**ATTACHMENT D**

**Proposed Amendment No. 107**

**Letter from C. R. Steinhardt (WPSC)**

**AFFECTED TS PAGES**

Indicated Temperature (°F)  
**FIGURE TS 3.1-1**

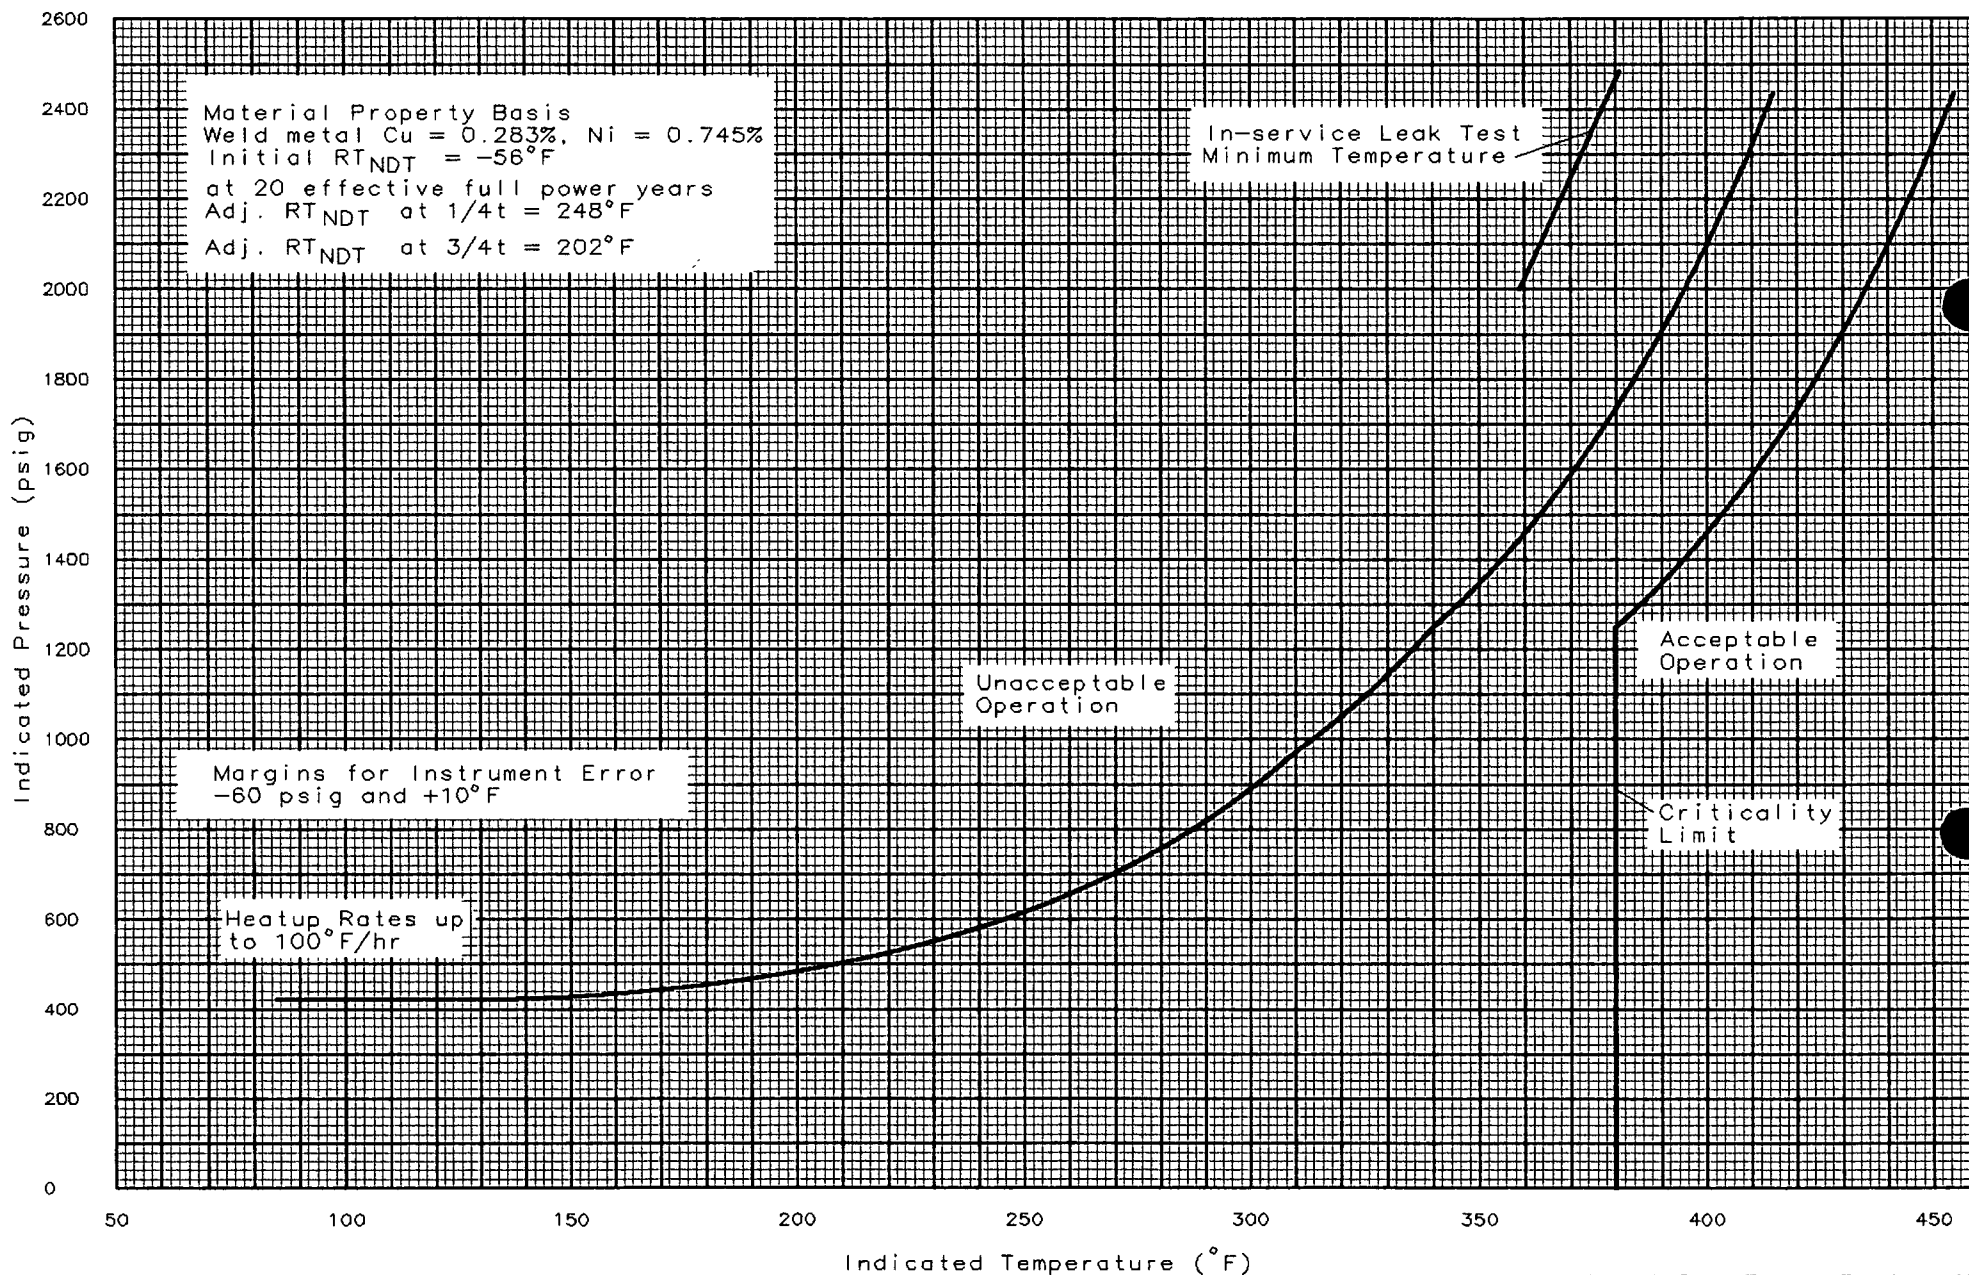
1. The reactor coolant temperature and pressure and system heatup and cooldown rates (with the exception of the pressurizer) shall be limited in accordance with Figures TS 3.1-1 and TS 3.1-2 for the service period up to 20 equivalent full-power years.

- A. Allowable combinations of pressure and temperature for specific temperature change rates are below and to the right of the limit lines shown. Limit lines for cooldown rates between those presented may be obtained by interpolation.

- B. Figures TS 3.1-1 and TS 3.1-2 define limits to assure prevention of non-ductile failure only. For normal operation other inherent plant characteristics, e.g., pump heat addition and pressurizer heater capacity may limit the heatup and cooldown rates that can be achieved over certain pressure-temperature ranges.
